FROM: Peter Johansson
 TO: T10 SBP-2 *ad hoc* Working Group
 DATE: February 14, 1997
 RE: Transport Status for SBP-2

The proposal below is intended to clarify and enhance the definition of *sbp_status* in SBP-2 Revision 2. For some time there has been general agreement that the status definition was not yet complete. Here is a starting point for discussion. Modifications to the existing SBP-2 Revision 2 clause are shown by change bars.

5.3 Status block

Figure 28 – Status block format

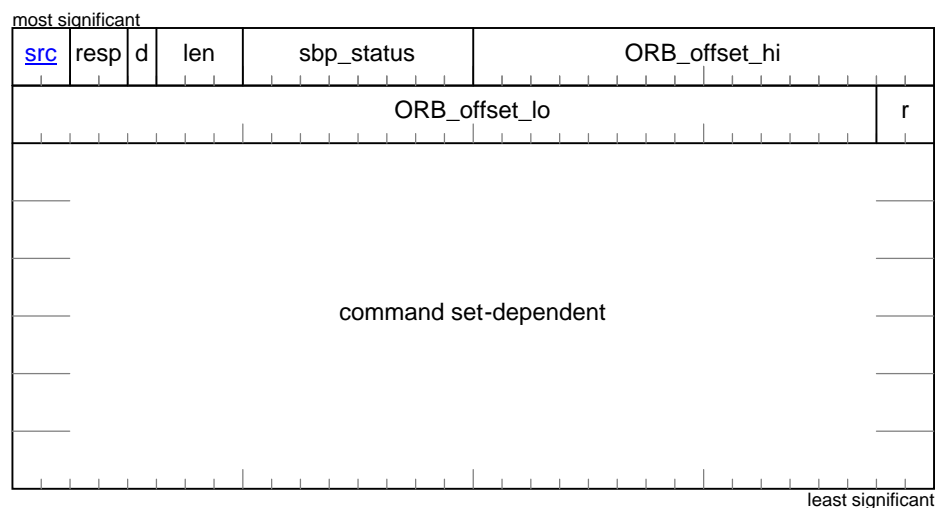
[The *src* field indicates the origin of the status block, as encoded by the table below.](#)

<u>Value</u>	<u>Description</u>
<u>0</u>	<u>The status block pertains to an ORB identified by <i>ORB_offset</i>; at the time the ORB was most recently fetched by the target the <i>next_ORB</i> field did not contain a null pointer.</u>
<u>1</u>	<u>The status block pertains to an ORB identified by <i>ORB_offset</i>; at the time the ORB was most recently fetched by the target the <i>next_ORB</i> field was null.</u>
<u>2</u>	<u>The status block is unsolicited and contains device status information; the contents of the <i>ORB_offset</i> field shall be ignored.</u>
<u>3</u>	<u>The status block is unsolicited and contains isochronous error report information as specified by X.</u>

~~The *unsolicited* bit (abbreviated as *u* in the figure above) shall specify the usage of the *ORB_offset* field. If the *unsolicited* bit is zero, the status block pertains to a request identified as described below. When *unsolicited* is one, the status block is not related to any outstanding request and the contents of *ORB_offset* shall be ignored.~~

~~The *end_of_list* bit (abbreviated as *e* in the figure above) shall specify the value of the *next_ORB* field of the ORB to which the status block pertains at the time the ORB was most recently fetched. When *end_of_list* is zero, the *next_ORB* field did not contain a null pointer. Otherwise *next_ORB* was null when last fetched.~~

The *dead* bit (abbreviated as *d* in the figure above) shall indicate whether or not the target fetch agent transitioned to the dead state upon storing the status block. When *dead* is zero, the reported status has not affected the state of the fetch agent. If the *dead* bit is set to one, the fetch agent transitioned to the dead state as a consequence of the error condition reported by the status block.
